Subsurface Exploration and MSE Wall and Embankment Evaluations for Proposed US 23 / SR 823 Interchange

**Peter
Narsavage/Structures/CEN
/ODOT**
06/30/2006 01:00 PM

To David Norris/Administration/D09/ODOT@ODOT
cc thampshire@dlz.com, pnix@dlz.com
bcc
Subject SCI-823 and 23 interchange MSE walls

From:	Mike Weeks
Subject: MSE Wall Evaluations for US 23 Interchange	
Project Name: SCI-823-0.00 PID 19415	
Project No: P403030064

LOG OF: Boring B-1107

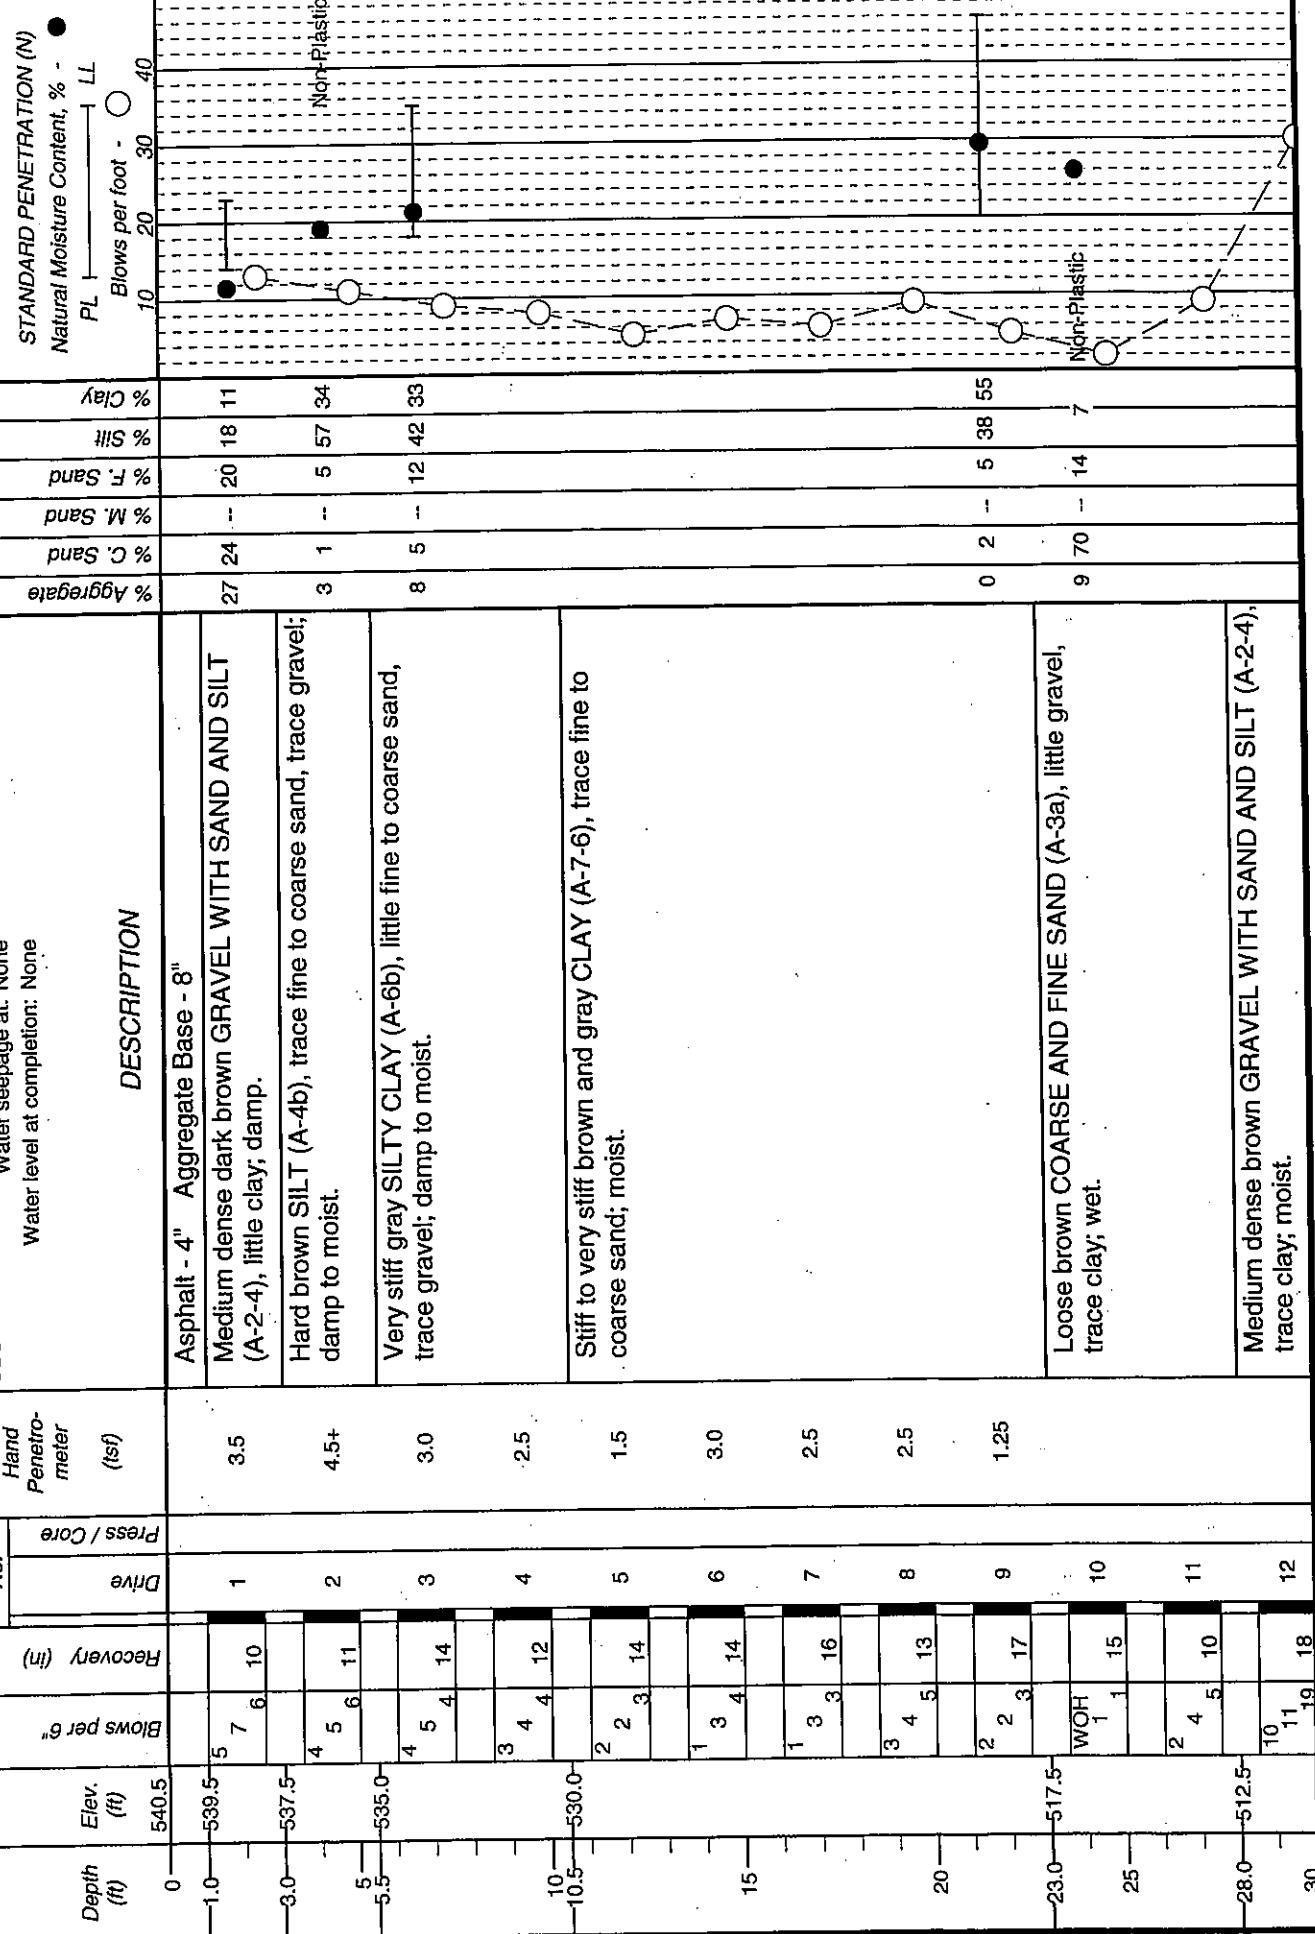
B-1107 10.5-23 A-7-c $s_u = 1.25 - 3.0 \text{ ksf}$ $w = 29 \text{ msf}$

LOG OF: Boring B-1109

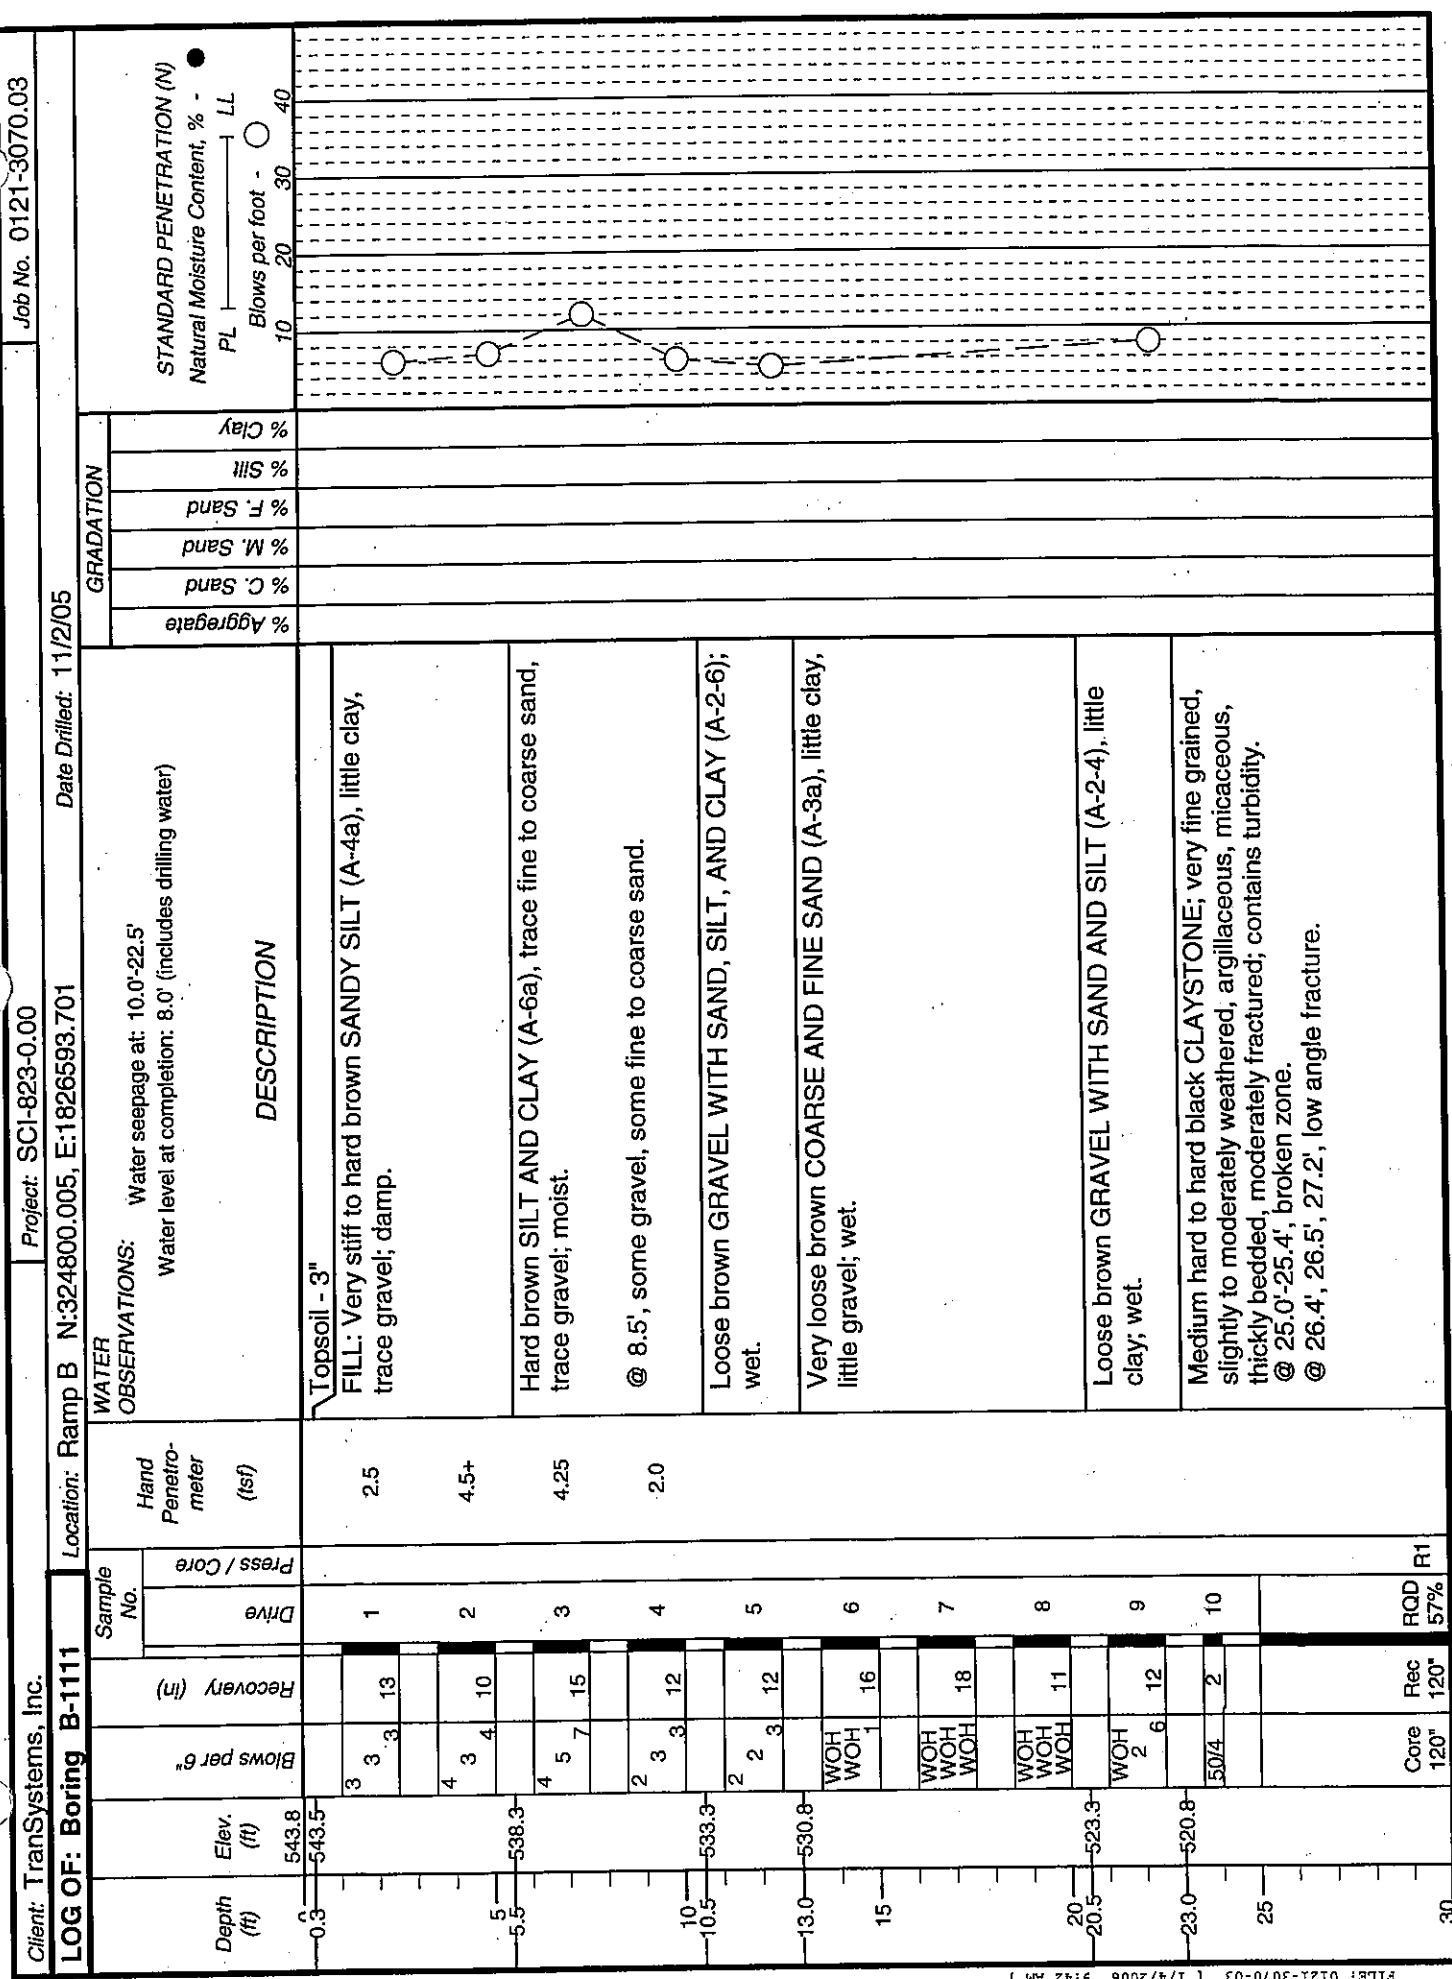
B-1109 w/ 5' undercut $\phi = 34^\circ$

LOG OF: Boring B-1122

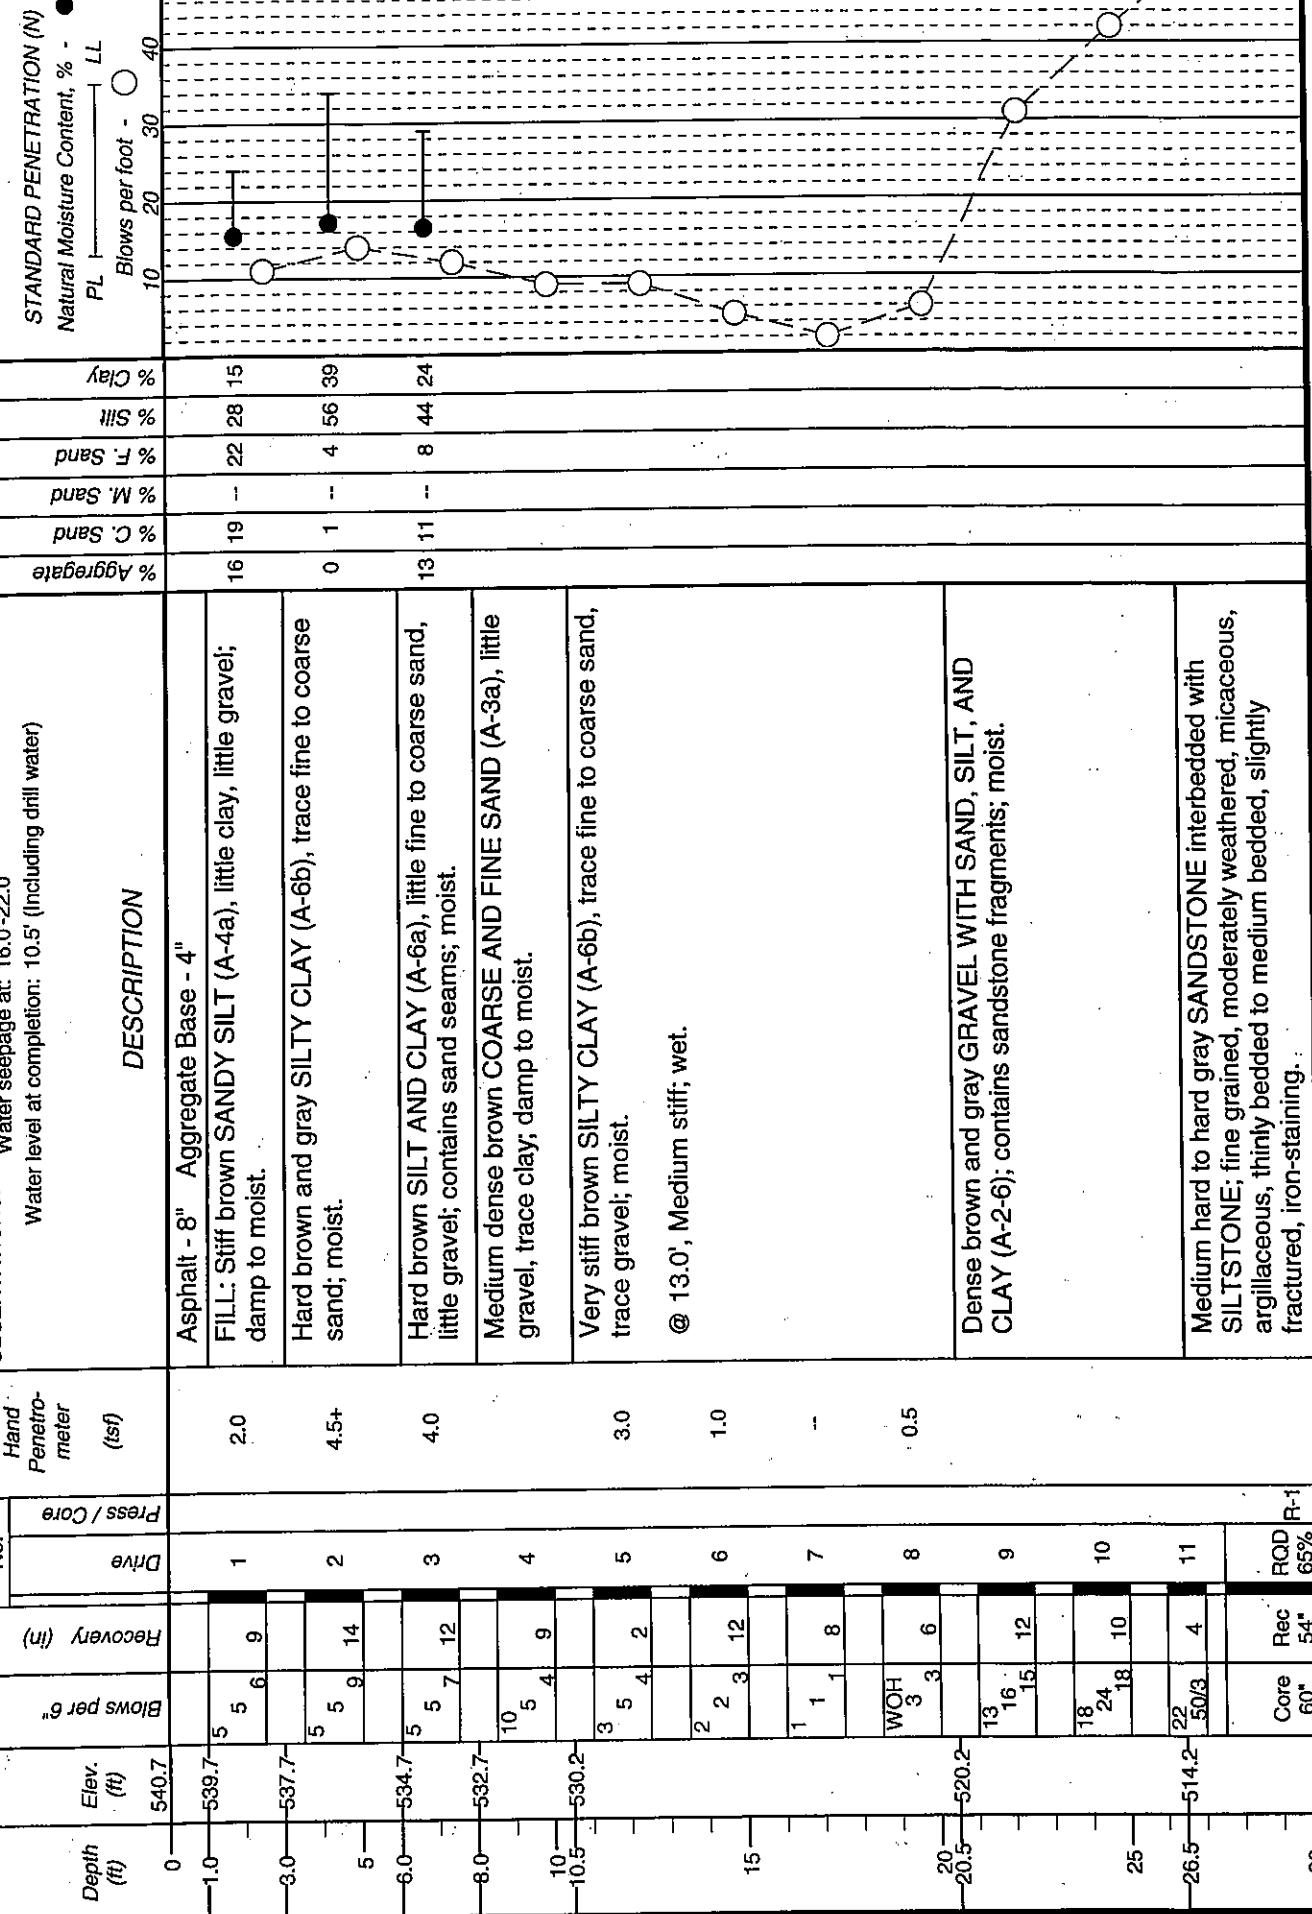
B-1122 13-20.5 A-6b $s_u = 0.5 - 1.0 \text{ ksf}$ wet

LOG OF: Boring B-1123 Project: SCI-823-0.00

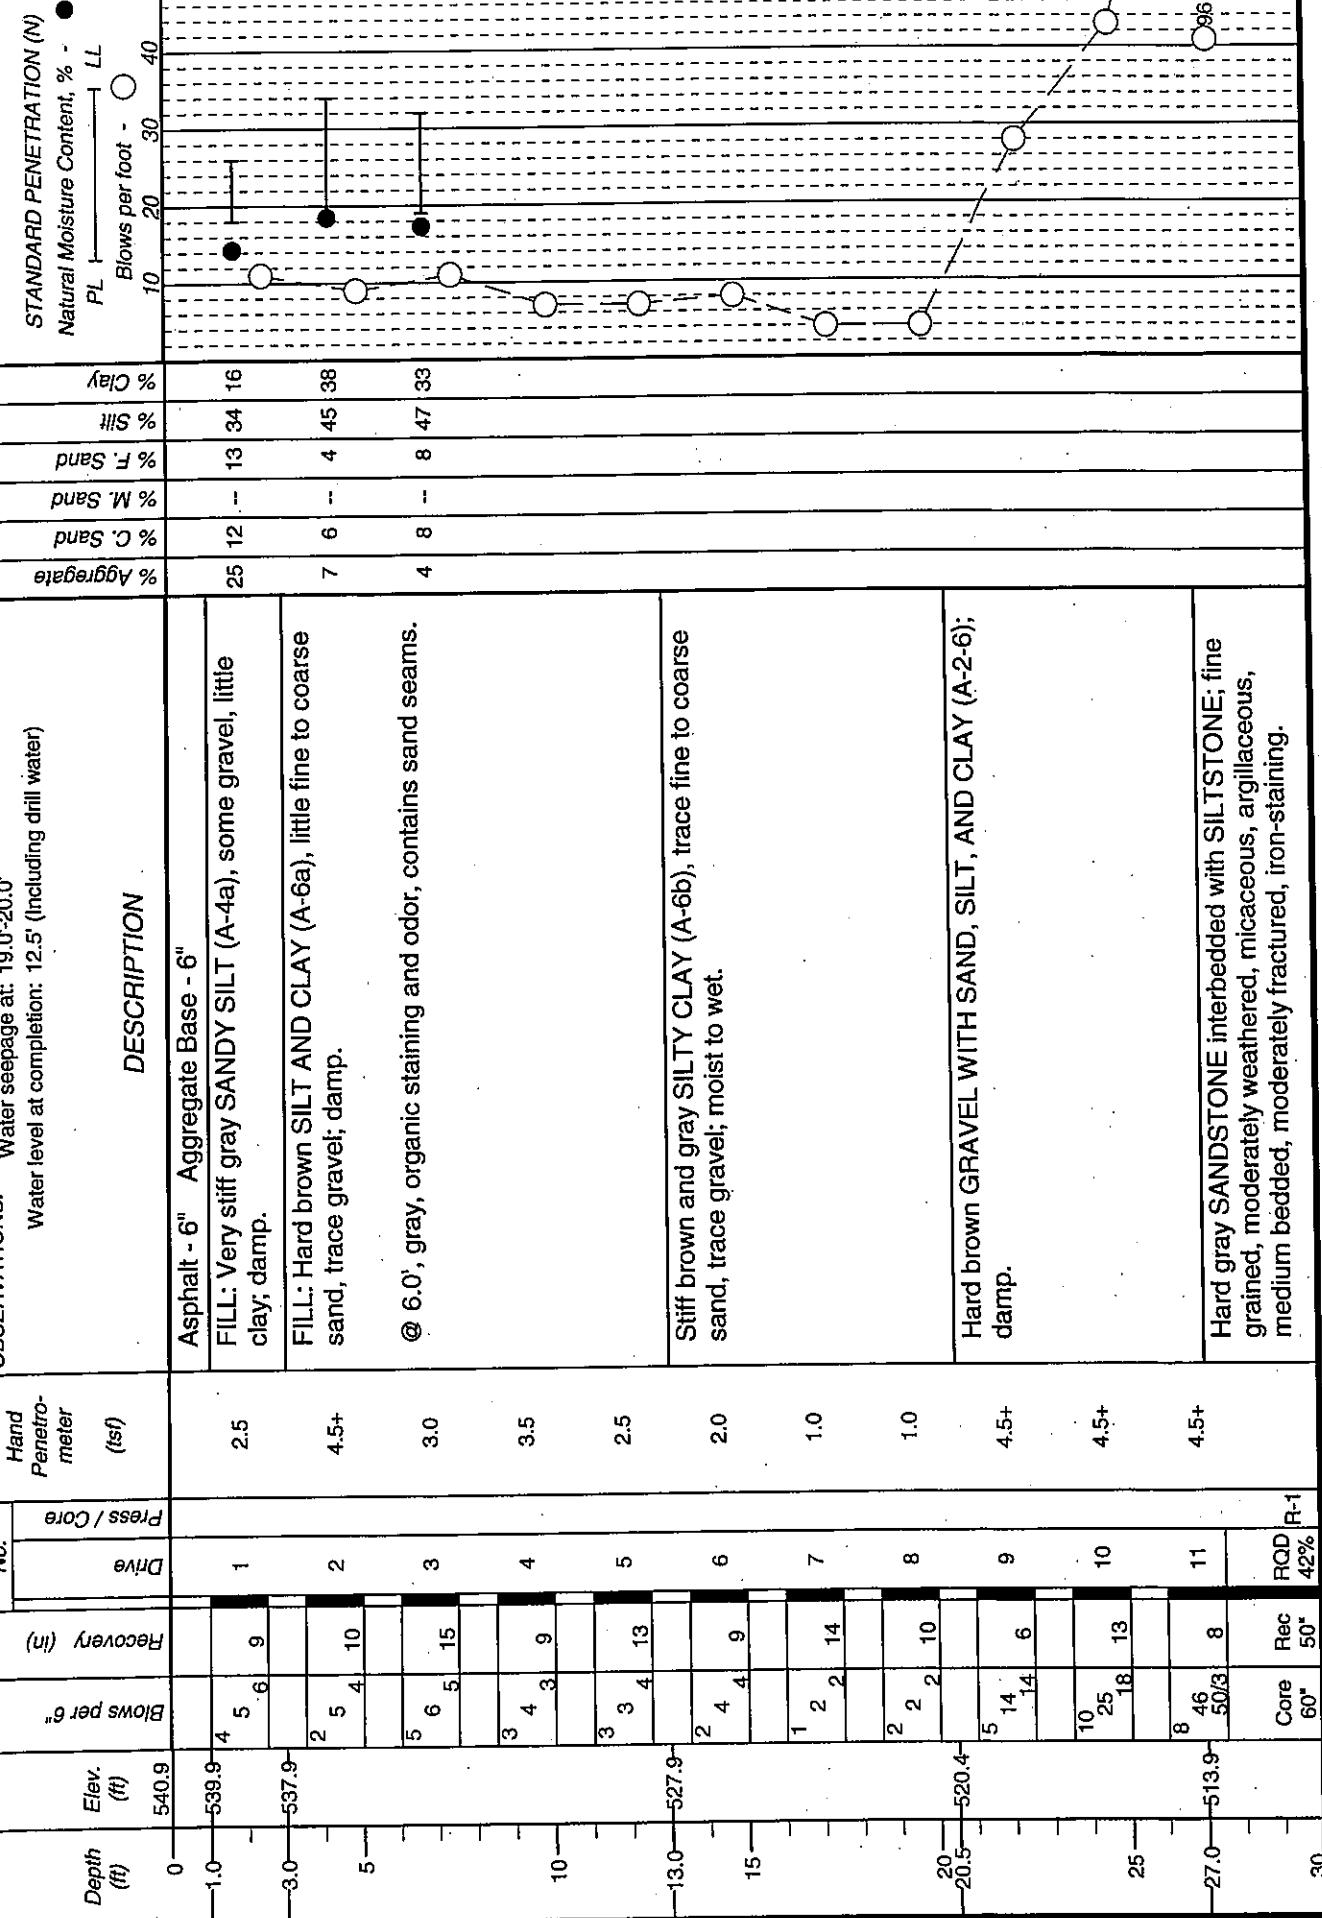
B-1123 13-20.5 A-6b $s_u = 1.0 - 2.0 \text{ ksf}$ moist-wet
